**Village of Paw Paw
Planning Commission Regular Meeting
Thursday, February 6, 2025**

To: Village of Paw Paw Planning Commission
Date: January 30, 2025
From: Tricia Anderson, AICP
RE: **Special Land Use Request for PUD – Heritage Woods Condominium Development (Tabled 1/2/25)**

HERITAGE WOODS CONDOMINIUMS

1/29/25
Sheet
C-2

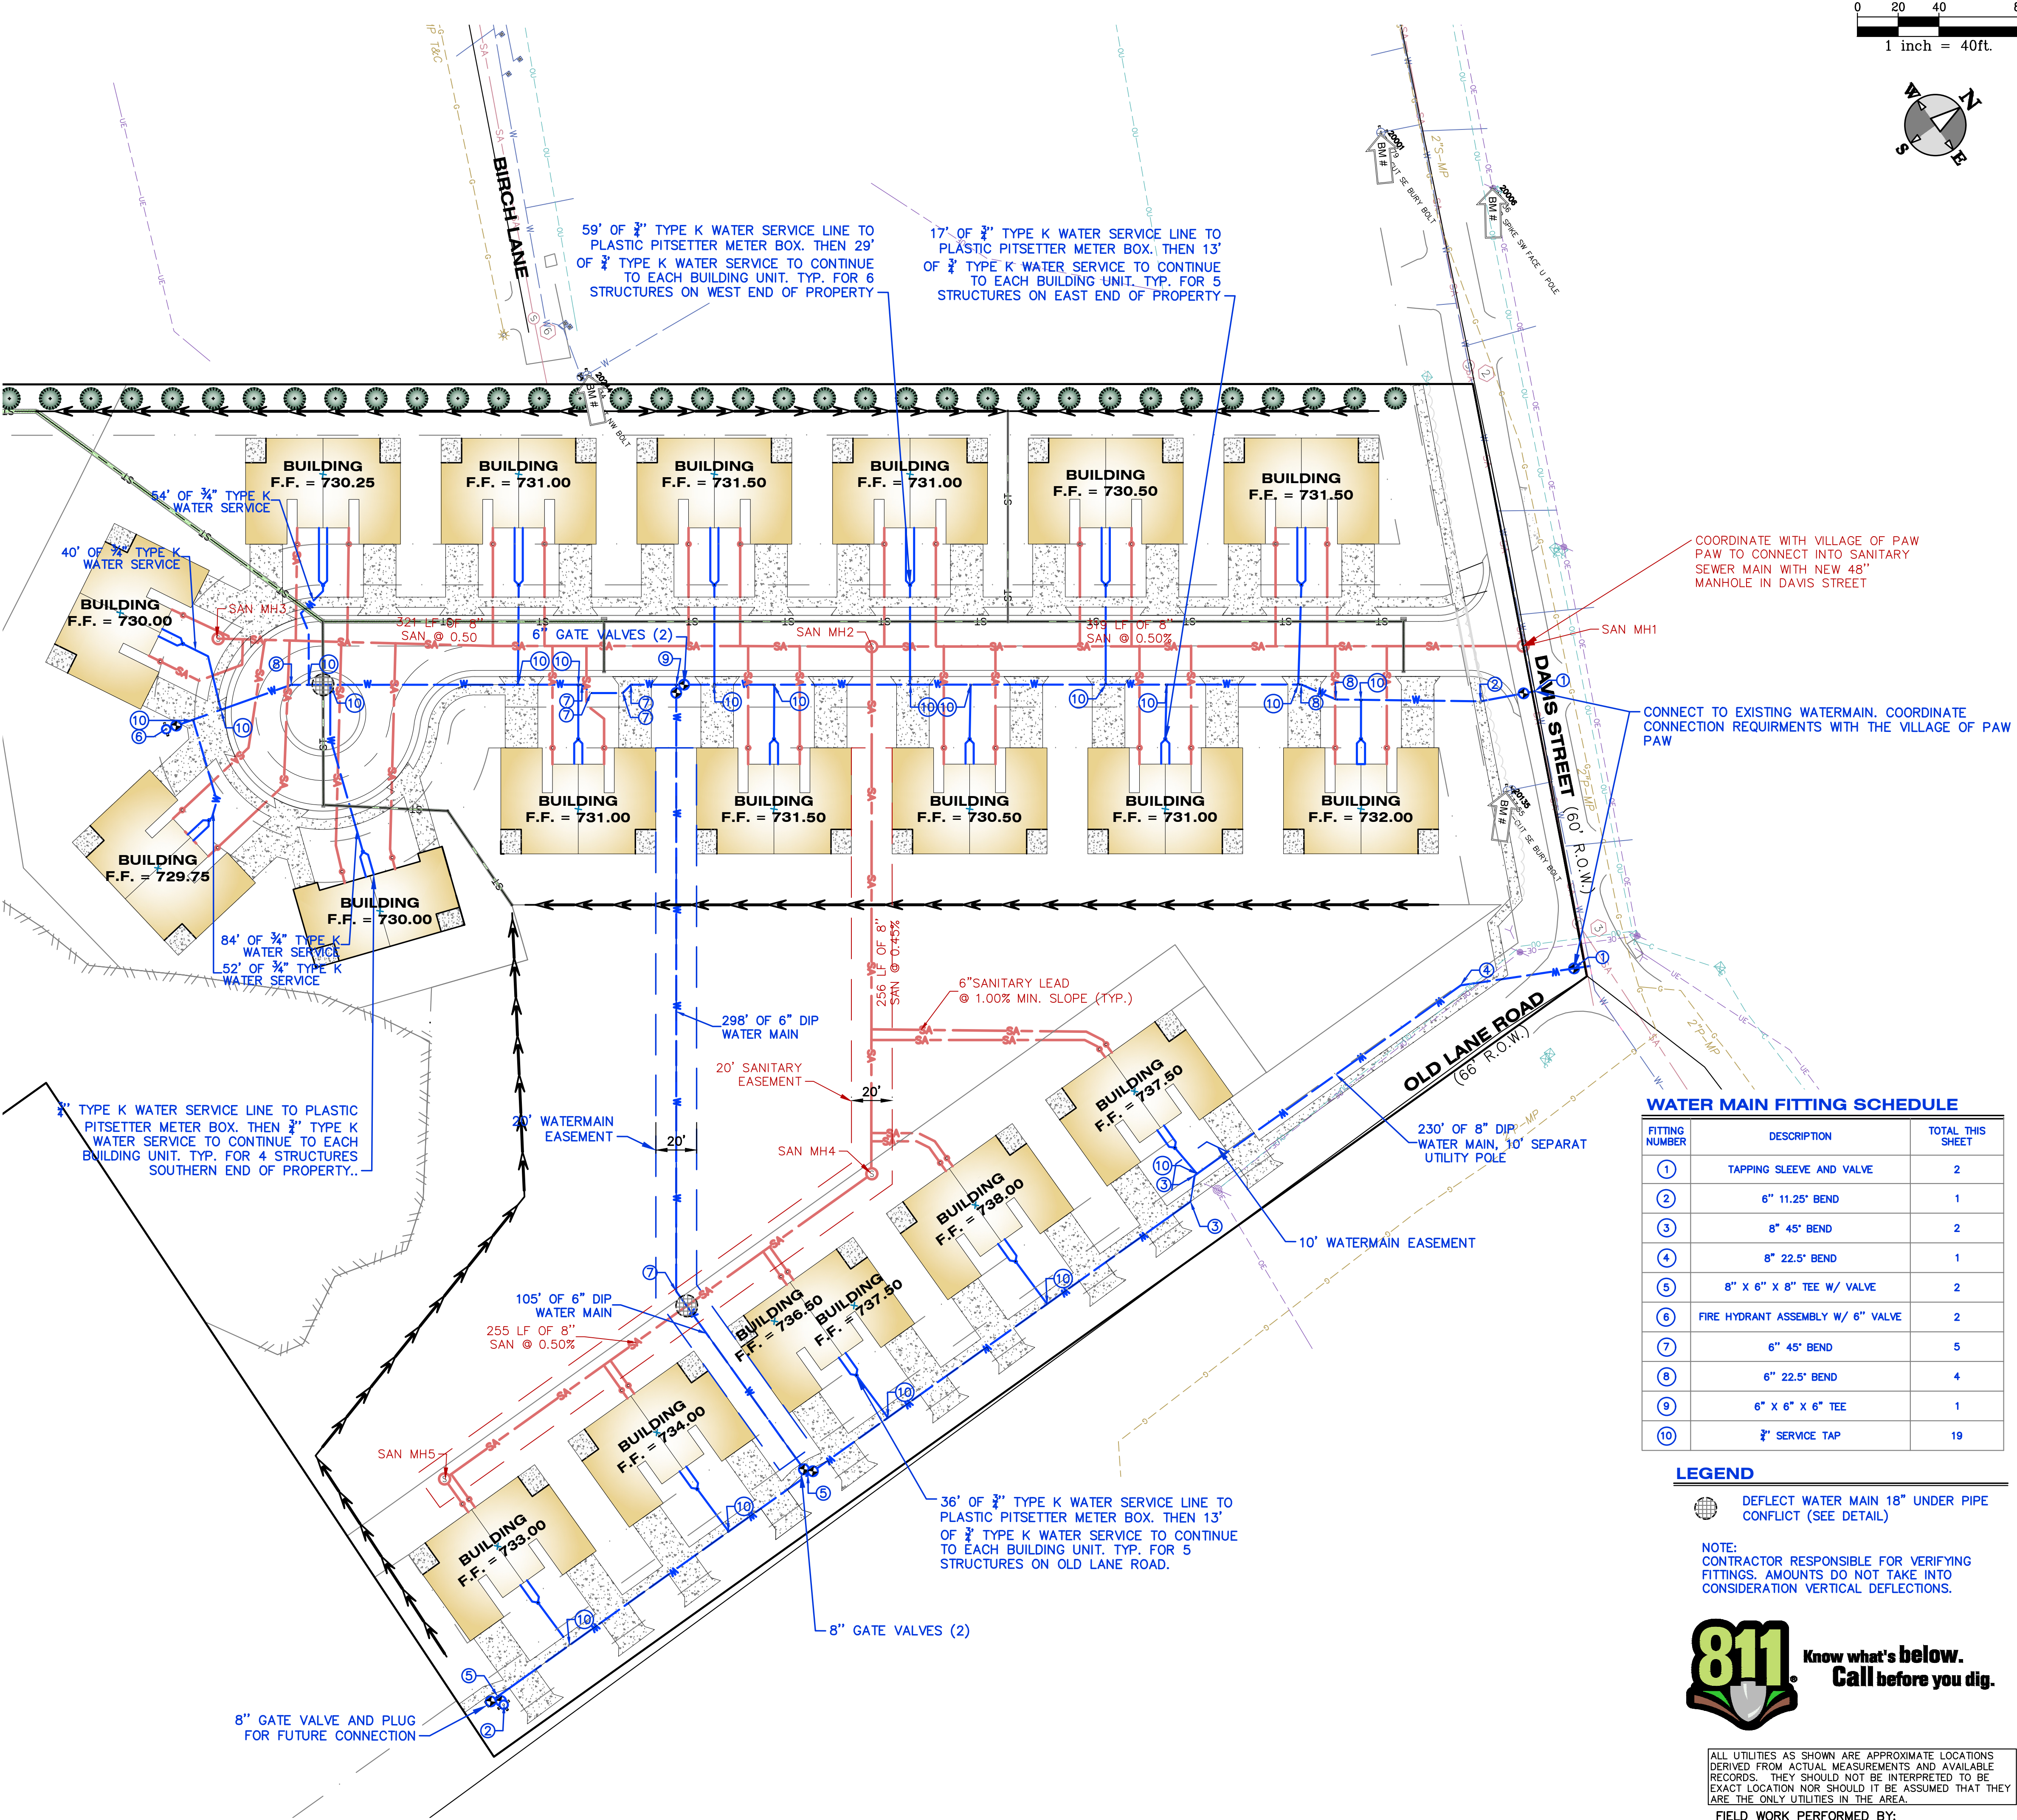
f. <i>Planted and maintained landscaped buffer areas of ten feet in width are required along all exterior boundaries of the property to be developed.</i>	This standard does not appear to be met. The applicant has not provided a landscape plan, nor is there a delineation of the buffer areas on the site plan. The applicant should provide this information in a revision to the site plan.	This standard appears to be met with a 10' wide buffer strip shown on the plan, along with a row of 35 Colorado Spruce trees within the buffer along the rear yards of units 1-12. The Planning Commission should determine whether additional landscaped buffer areas should be added to the plan along boundaries that do not abut developed areas.

- 10.** The master deed described in Condition #9 shall contain a provision acknowledging the responsibility to install and maintain 35 Colorado Spruce trees along the property line as shown on Sheet C-3 and as described in the Landscape Notes on the plan set dated 1/29/2025.

- 11.** The applicant shall install the 35 Colorado Spruce trees along the property line as shown on Sheet C-3 and as described in the Landscape Notes on the plan set dated 1/29/2025 prior to the issuance of any building permits. If the growing season is not ideal at the time the applicant requests building permits, the applicant shall provide the Village with a performance bond in the amount equal to the cost of the 35 trees and their installation as documented on a quote from a landscaping company or nursery, prior to the issuance of a building permit. The applicant will be reimbursed upon the planting of the 35 trees as required during the next viable planting season.

PRIVACY FENCE DETAIL

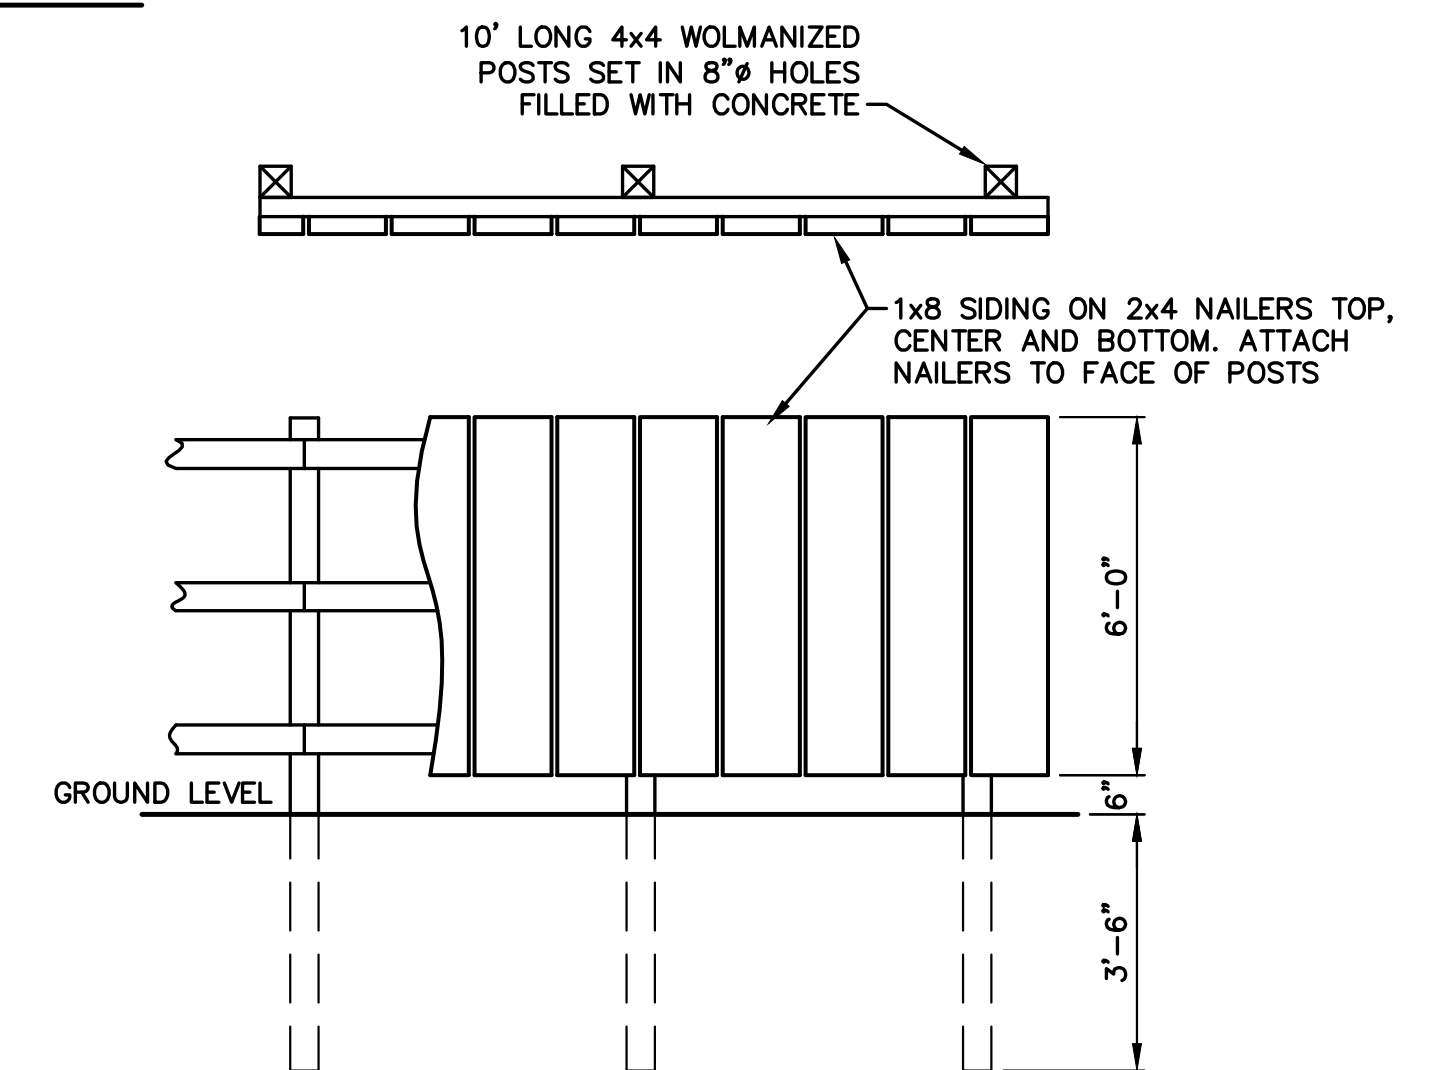
h. location, height, and material of all walls, fences and screen plantings, including a general plan for the landscaping and/or screening of the development and the method by which the landscaping and/or screening is to be accomplished and maintained.	A landscaping plan was not included with the submittal. Section 42-403 requires a 10' wide planted landscaped buffer along all boundaries of the property to be developed.	Met. The revised plan set includes a delineated 10' wide planted buffer strip behind units 1-12. The buffer strip includes 35 5' tall Colorado Spruce trees planted 20' on center at 7' off the property line. A fence does not appear to be proposed; however, a privacy fence detail is provided on Sheet C-8. This should be clarified by the applicant.

This standard appears to be met, however, as noted in Table 2, the plan contains a fence detail that should be removed if a privacy fence is not proposed.
